Preferred Project Report

For:
Proposed Six Storey Commercial Building with
Two Storey Basement Car Park, Associated
Plant, Signage and Subdivision of Lot 8b

At:
8b Murray Rose Avenue,
Sydney Olympic Park

Application Number: MP10_0214

A07.01[04]

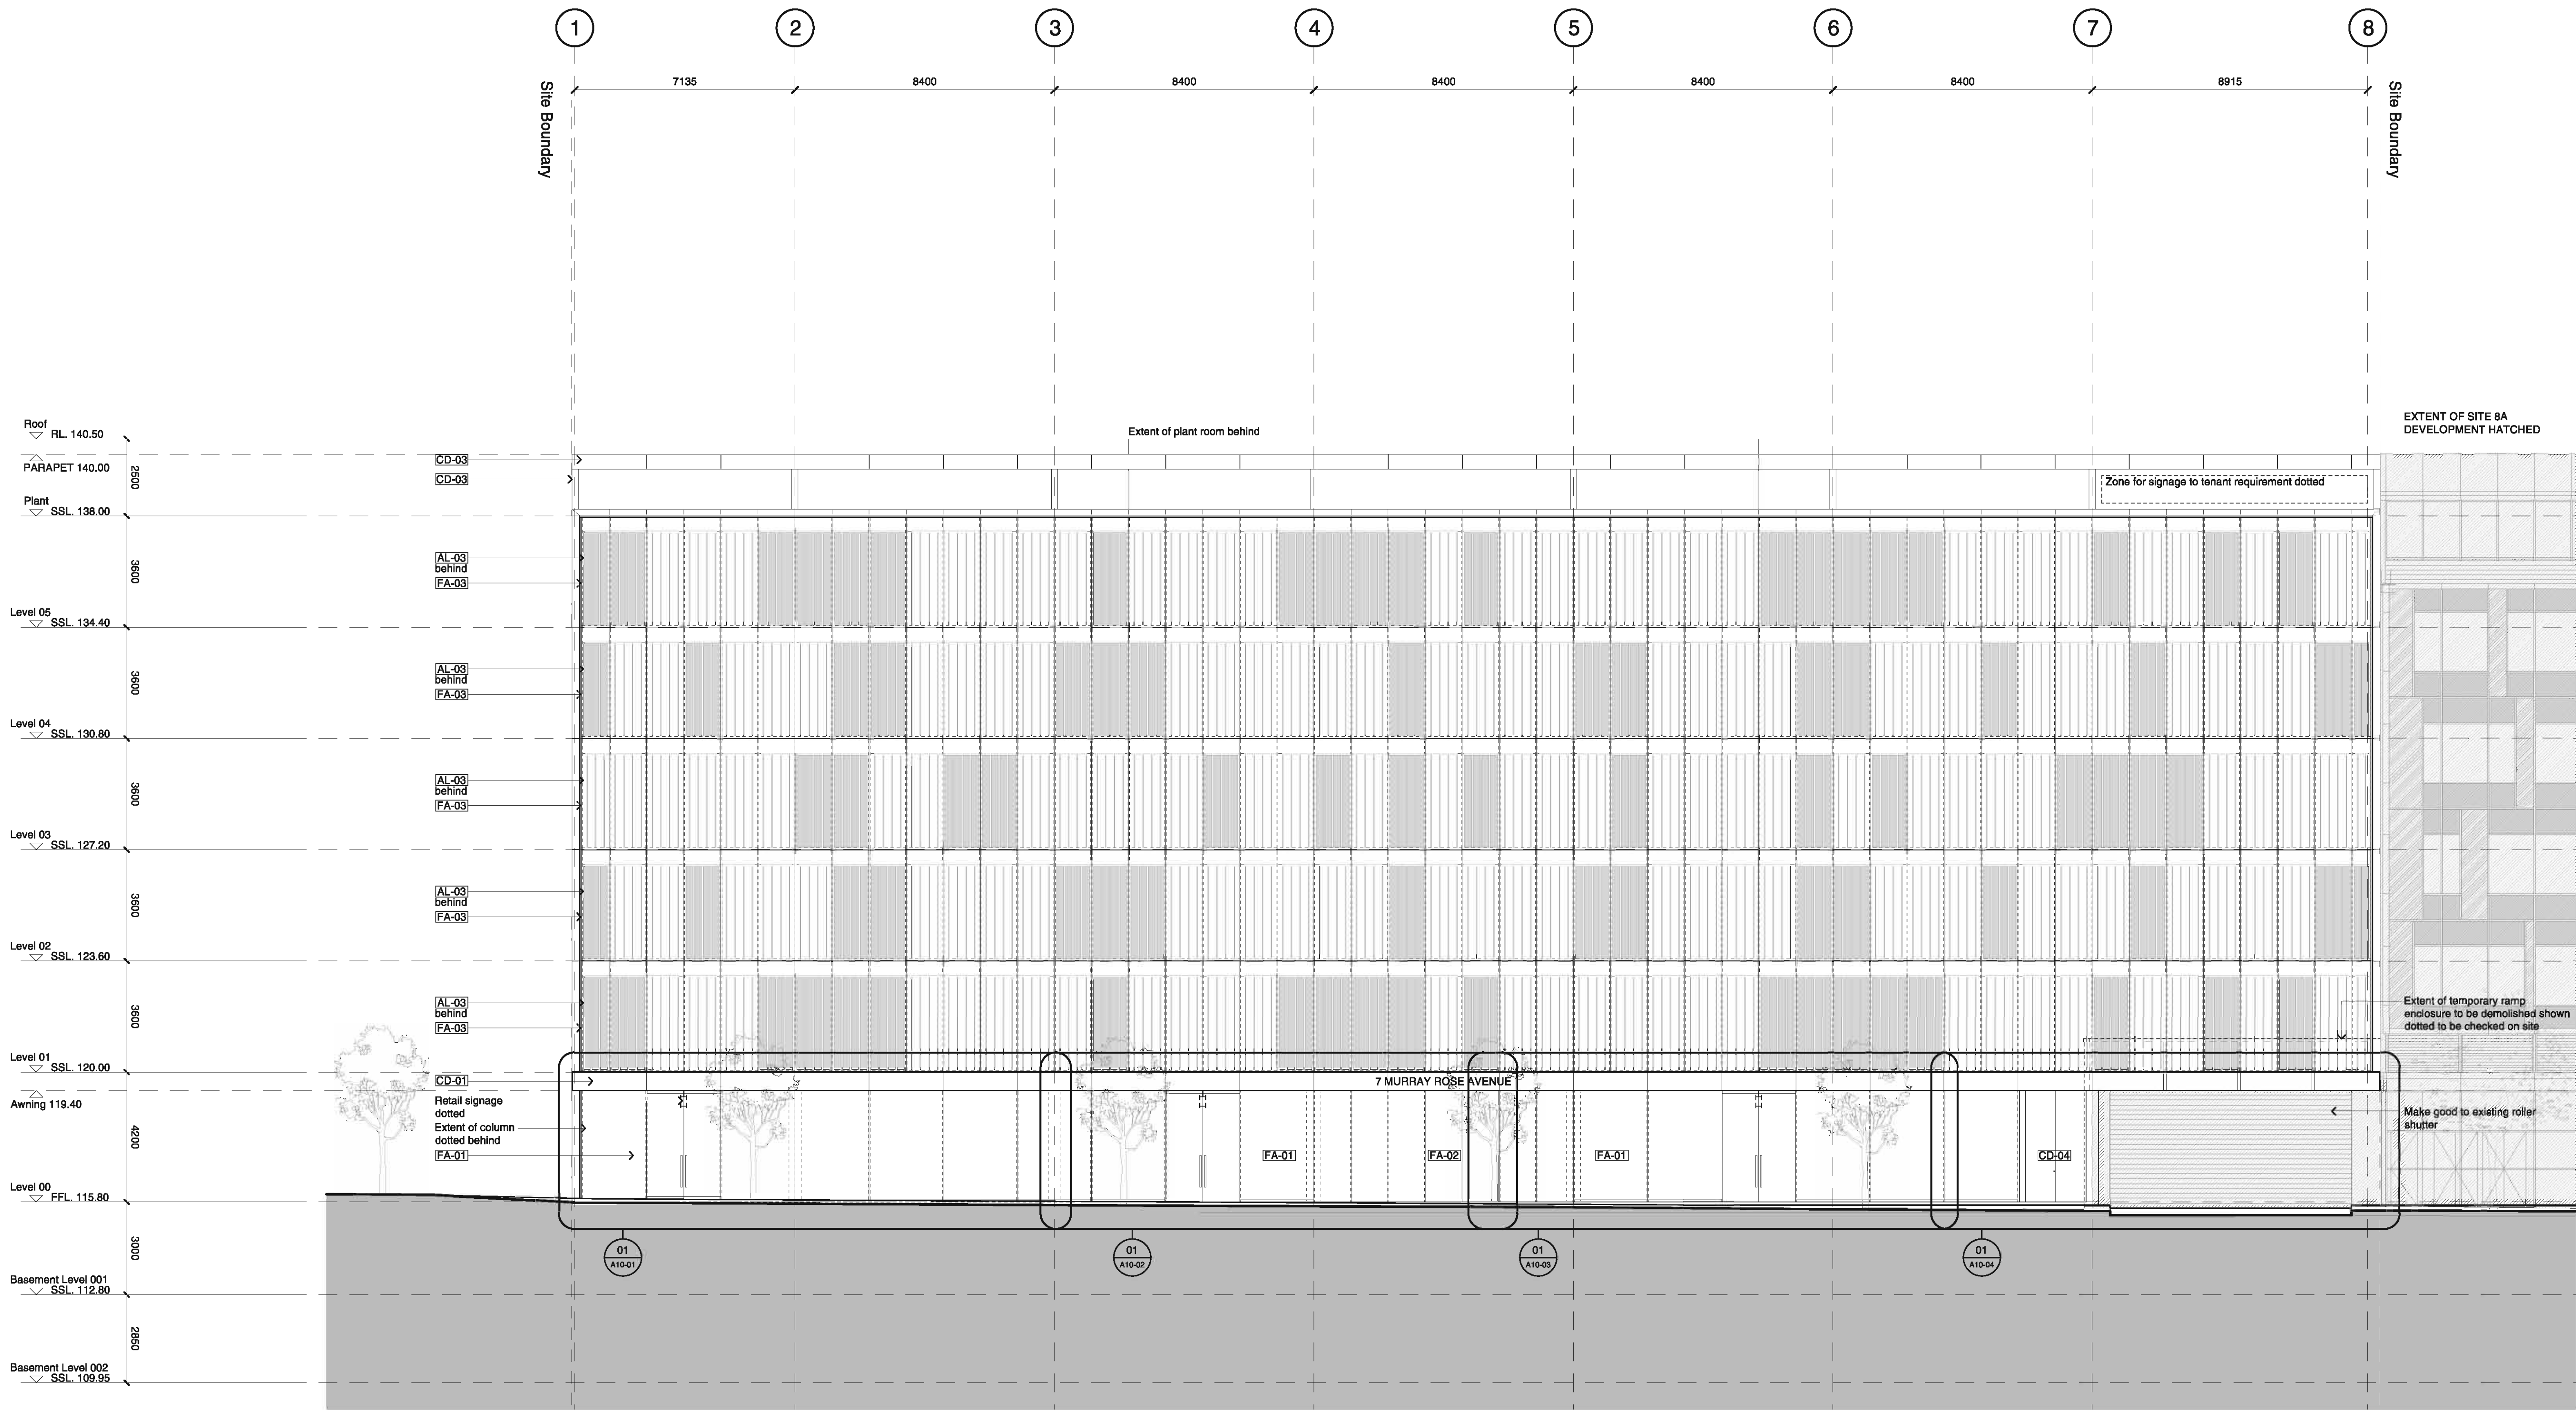
Glazing systems It appears that the street elevation is provided with identical glazing system as the upper levels, with mullions at 1200mm centres. It is considered that larger glazed sections on the ground floor to activate the retail frontage, is more desirable.	Larger glazing sections have been incorporated at street elevation. Please refer to attached Drawing A07.01 [04].
Vertical blade system The drawings suggest that the perforated aluminium blades/blinds are 250 – 300mm wide; this is a minimum acceptable width and should not be reduced.	The perforated aluminium blades are 300mm wide.

Larger glazing sections have been incorporated at street elevation. Please refer to attached Drawing A07.01[04].

Section 1

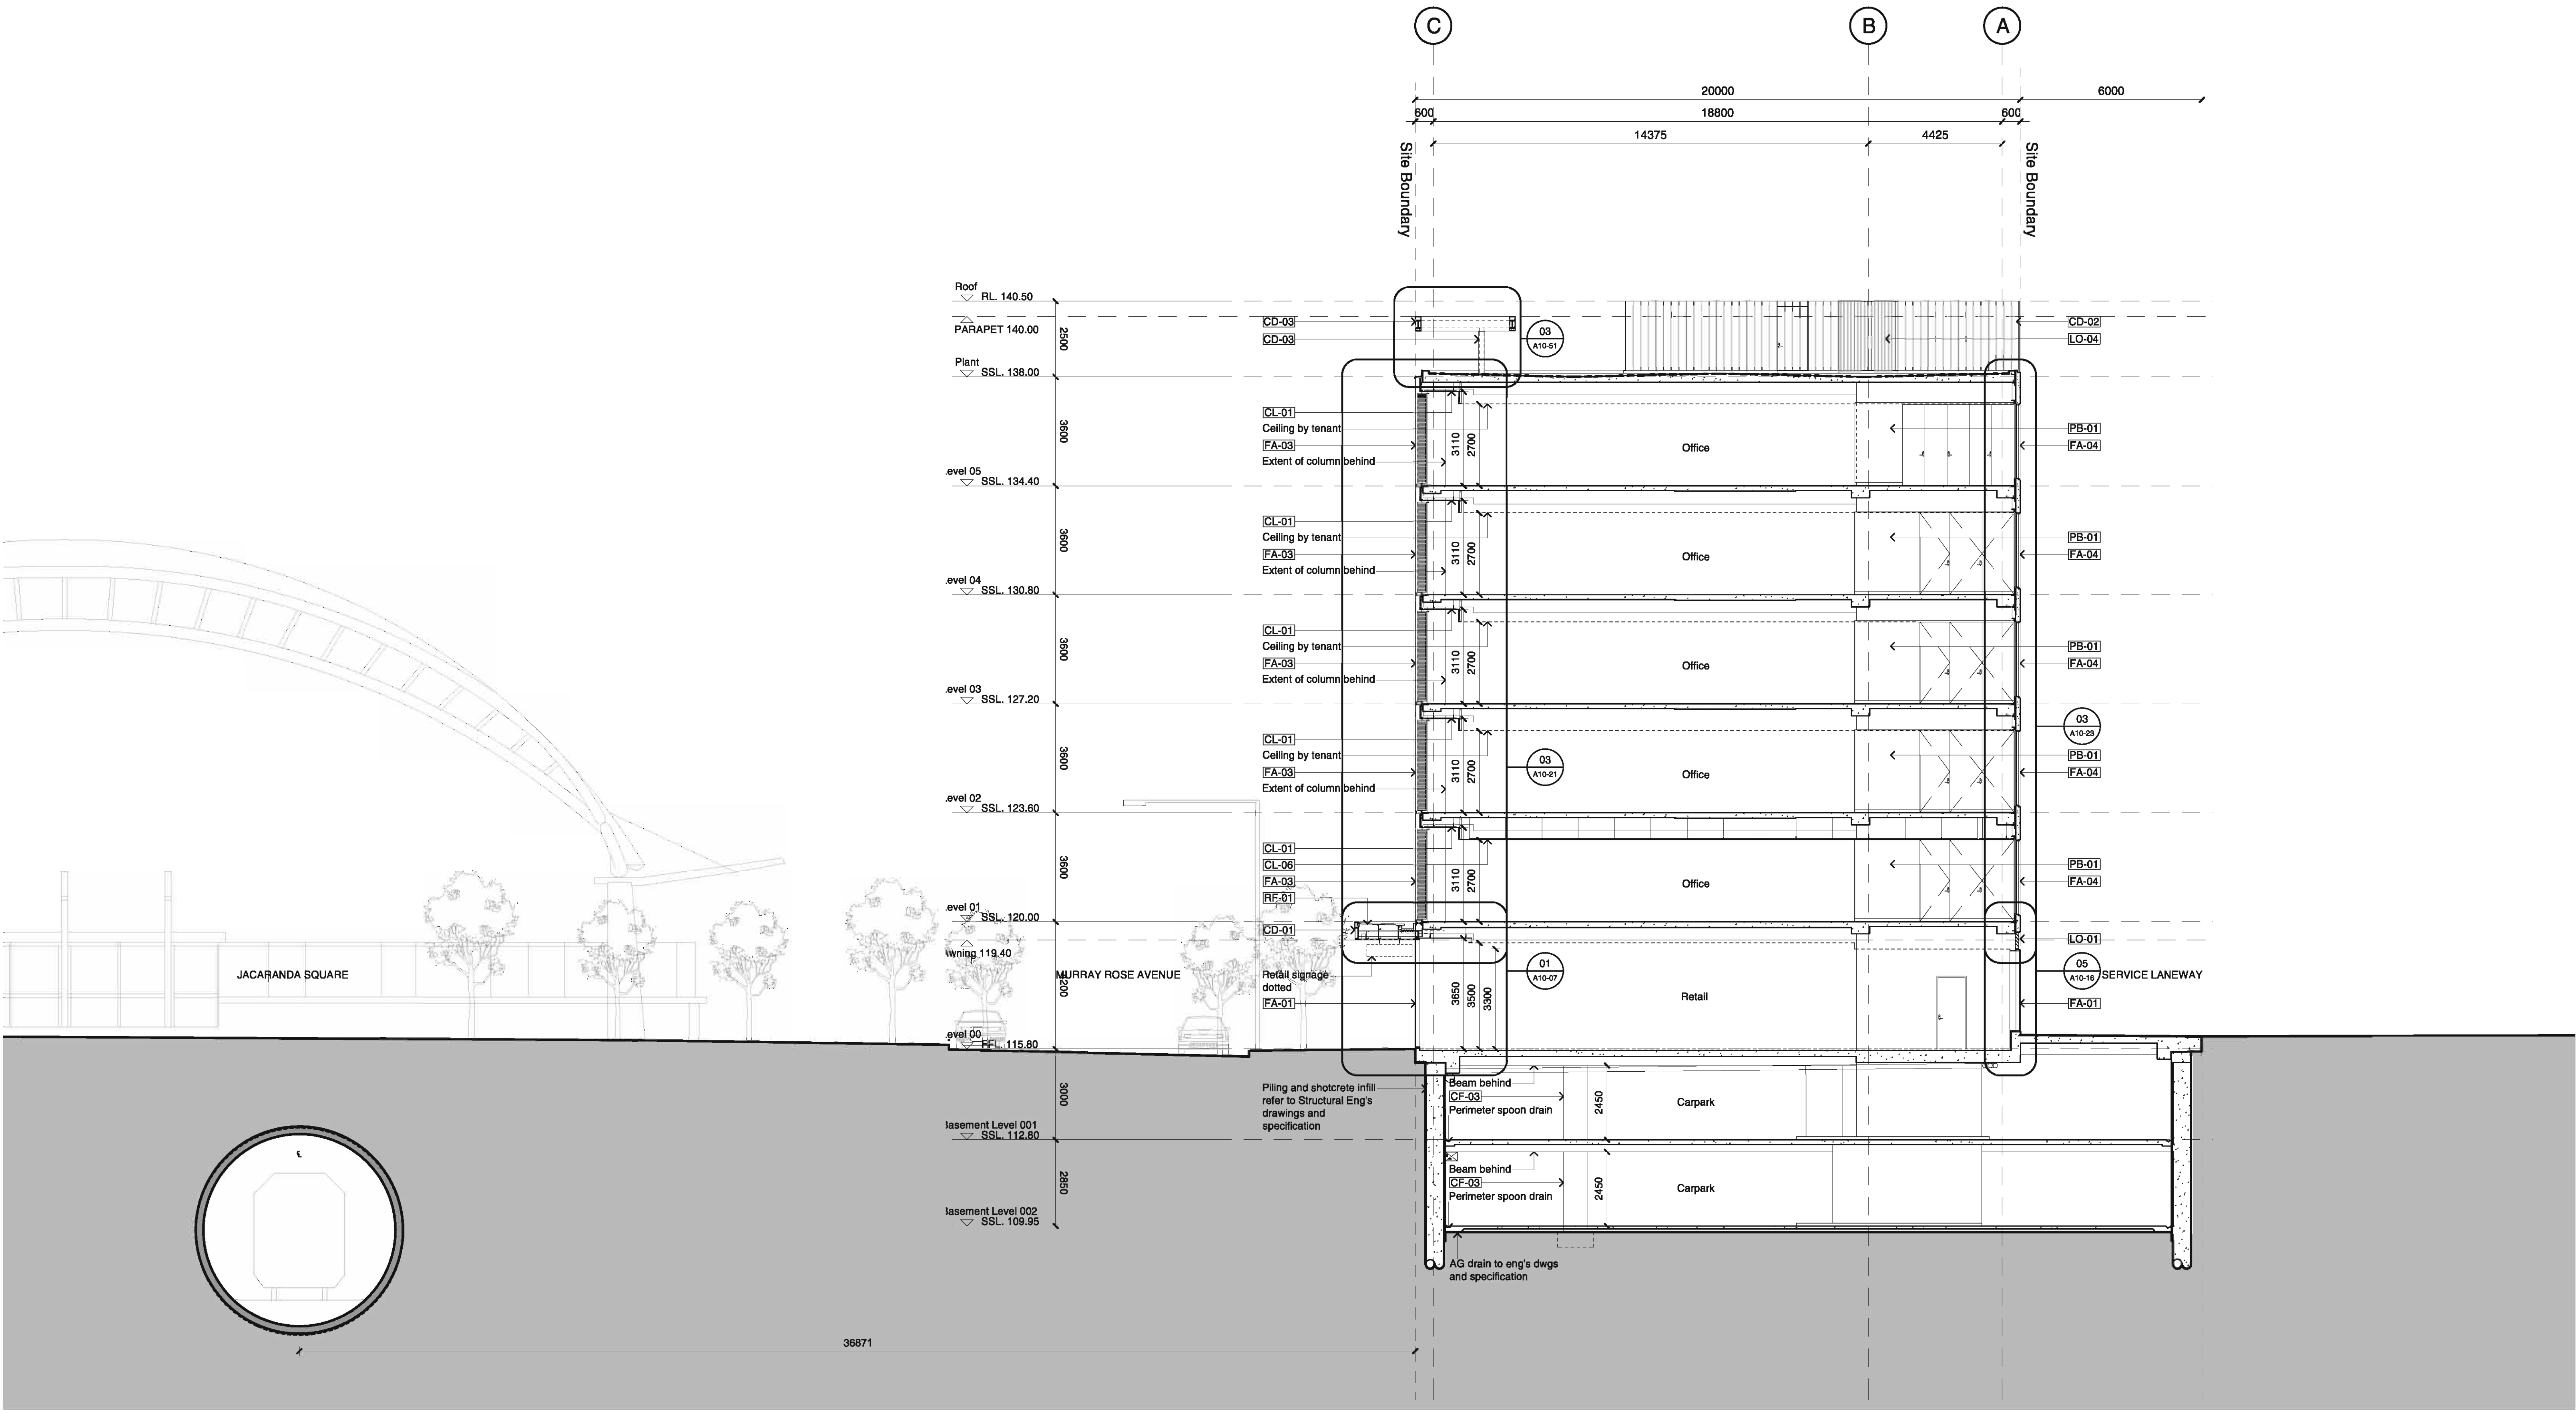
SUBMISSION ISSUES	RESPONSE
Floor to Floor Height It appears that the floor to floor height on the ground floor does not comply with MP 2030. At minimum, the clearance should be 3.3m (higher clearance is desirable). Note: Drawing No. A06.002(C) indicates an RL of 129.4 (correct RL is 119.4) to the soffit of the awning.	Floor to ceiling height on Ground Floor generally is 3.6m to the soffit of the awning and continues inside the Lobby with “see through” modular ceiling grid at 3.35m above finish floor level. It provides extended sightline to the exposed soffit at 4m from floor finish. Please refer to attached Drawing A08.02 [04].
Awnings It is noted that the awnings proposed are only 2m wide. Awnings are to be 3m width as required by MP 2030.	In response to SOPA's urban design principles and to create a unified frontage along Murray Rose Avenue ensuring consistency along the pedestrian footpath, the proposed awning is to be continuous and to match existing Site 8A in height, alignment and proportions – which is 2m wide. Widening the awning into 3m in width will create a break and inconsistency along pedestrian footpath. The urban design principles won't be achieved as the scale and continuity along footpath do not match existing awning. We strongly recommend the proposed awning to match existing Site 8A, which is 2m in width.

- Clarified Ground Floor ceiling height to show compliance with the relevant provisions of the Sydney Olympic Park Master Plan 2030 (3.3 metres)
